HORSHAM DISTRICT COUNCIL CONSULTATION

TO:	Horsham District Council – Planning Dept
LOCATION:	Phases 2 and 3 Land at Wellcross Farm Broadbridge Heath
DESCRIPTION:	Application for Approval of Details Reserved by Condition 2 (Construction Management Plan), ³ (borehole to meet Private Water Supplies), ⁴ (Private Water Supply Management Plan), ⁵ (finished floor levels and external ground levels) and 7 (underground services) to approved application DC/24/0205 Reserved matters application pursuant to condition 5 of outline planning permission DC/19/1897 for the provision of phases 2 and 3 of Land at Wellcross Farm to provide a continuing care retirement community with 94 units of accommodation (C2), with access, infrastructure, open space, landscaping and associated works including an onsite borehole water supply).
REFERENCE:	DISC/26/0012 & DISC/26/0013
RECOMMENDATION:	Advice / Modification / More information.
2nd response in Red	Advice / Modification / More information.

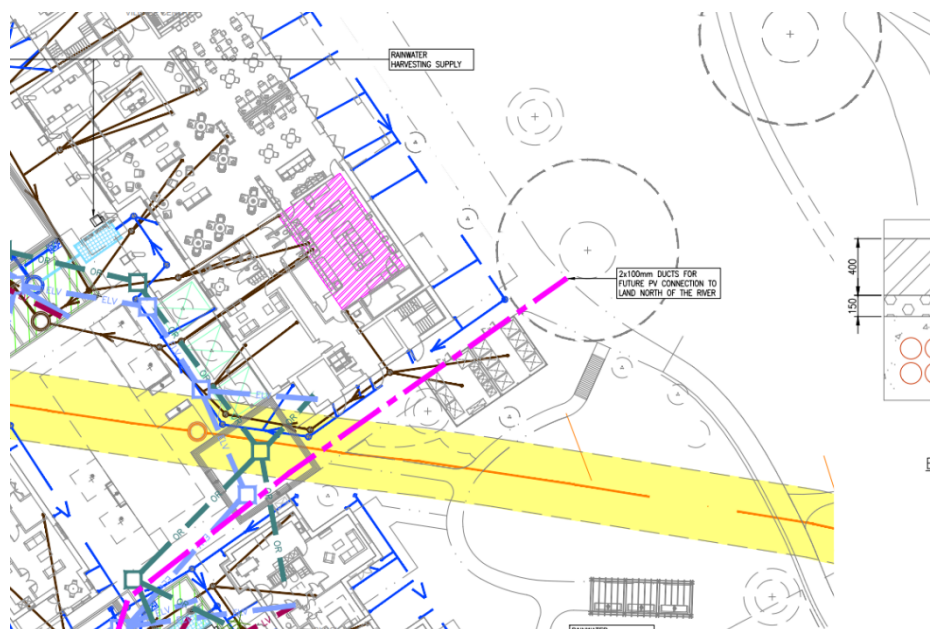
The RPA, of the unknown tree shown in the image above, taken from Electrical & Electrical Services Drawing No. 1163-ESD-XX-00-DR-XX-P2-1001, revision 2, still indicates that the ducts for the future PV connection to land north of the river fall within the tree's RPA. Please seek confirmation that the ducts will be removed and that the PV connection will not be sited within the RPA, or alternatively that trenchless installation methods will be used at a depth greater than 1.5 m below existing ground levels.

If the new services are installed using an open-trench method, the historically greenfield nature of the site and the absence of physical constraints that would have limited root development to the northwest of the tree indicate a high likelihood that trenching works would result in substantial root severance and long-term damage to T31.

Given the greenfield nature of the site, it is essentially unconstrained. As such, it is not considered that there would be any *overriding justification* for significant development, such as open-trench excavations, to take place within the RPA of retained trees. Ideally, the site layout and design should take appropriate account of existing site constraints, including retained on-site and off-site trees.

Accordingly, amendments should be sought to the route of the service runs to ensure that they do not encroach within the RPA of tree T31, and outside of the RPA, of the unknown tree in the above image taken from Electrical & Electrical Services Drawing No. 1163-ESD-XX-00-DR-XX-P2-1001.

One potential solution would be to relocate the service runs further north, outside the RPA of T31, and outside of the RPA, of the unknown tree in the above image. If this is not

considered feasible, trenchless installation methods should be employed, such as thrust boring or impact moling.

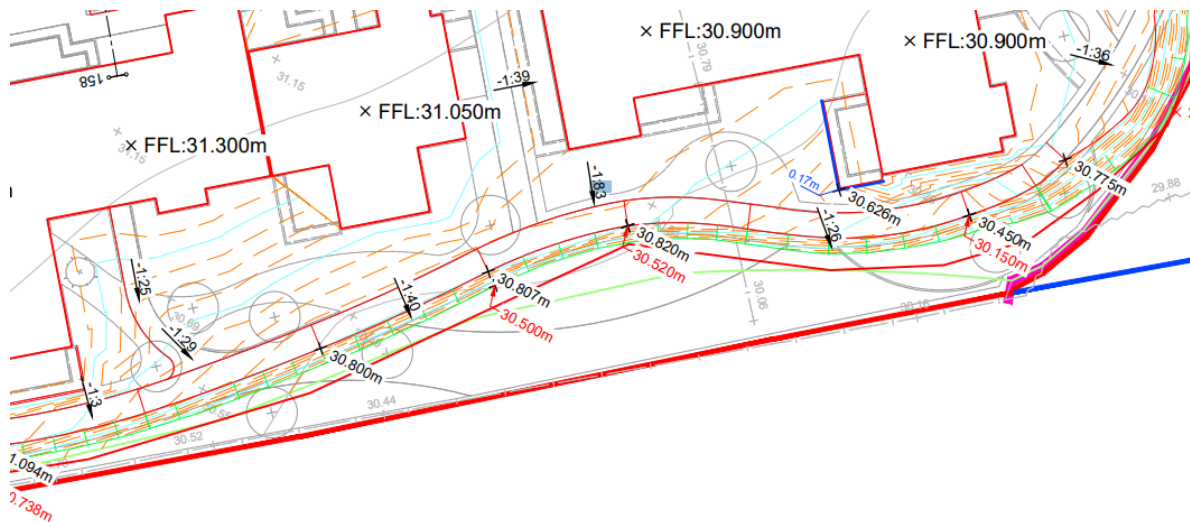
Further concerns are also raised in relation to the proposed landscaping works and associated land level changes in the area to the northwest of off-site trees T30 and T31, both oaks. Given the lack of detail on how the works would be completed without resulting in direct construction damage or indirect post-development harm, including root damage and soil compaction, these proposals are considered problematic. Please seek confirmation on the exact extent of the level changes and landscaping works within the RPA of T30, and T31.
